SERVICE BULLETIN

MODEL NAME : Di620
MODEL CODE : 1155
NO. : 007
DATE : 980709
SUBJECT : MANUAL FEED SECTION CHANGE

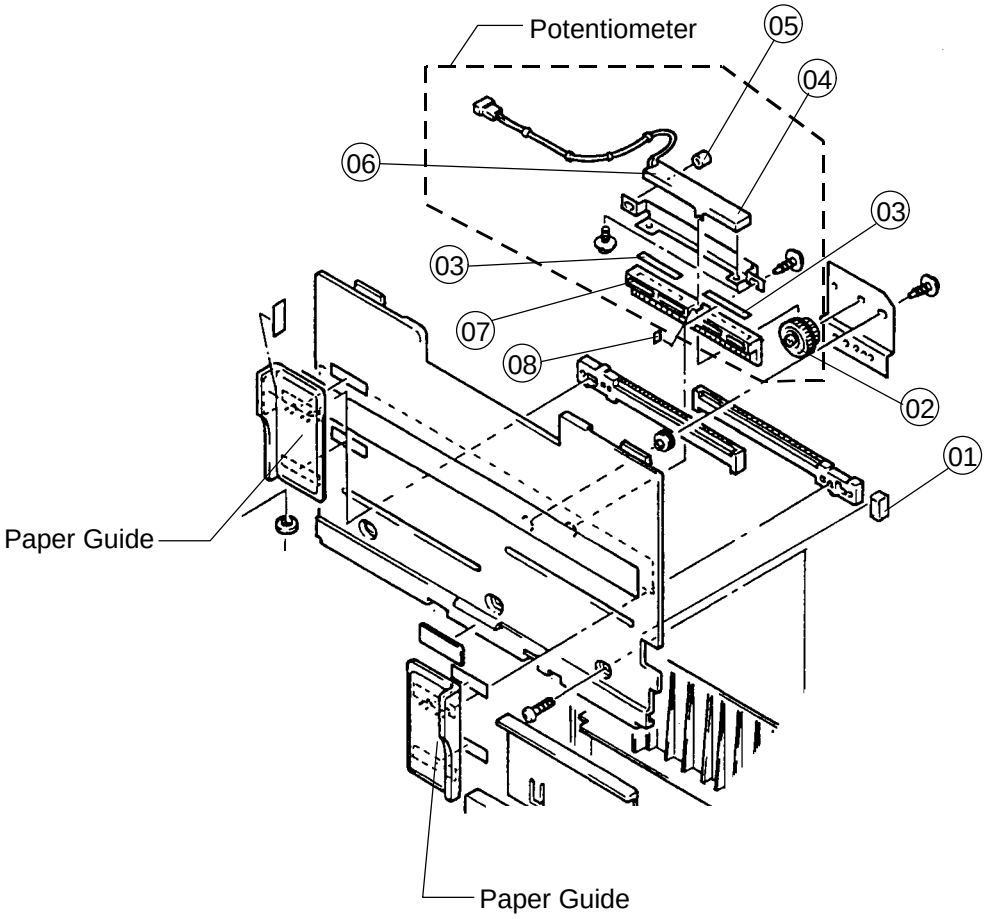
A potentiometer mechanism is not necessary for this machine, therefore, it has been removed. Due to this, the paper guides may be opened too far. To prevent this, a rubber cushion (01) has been added to the position shown below.
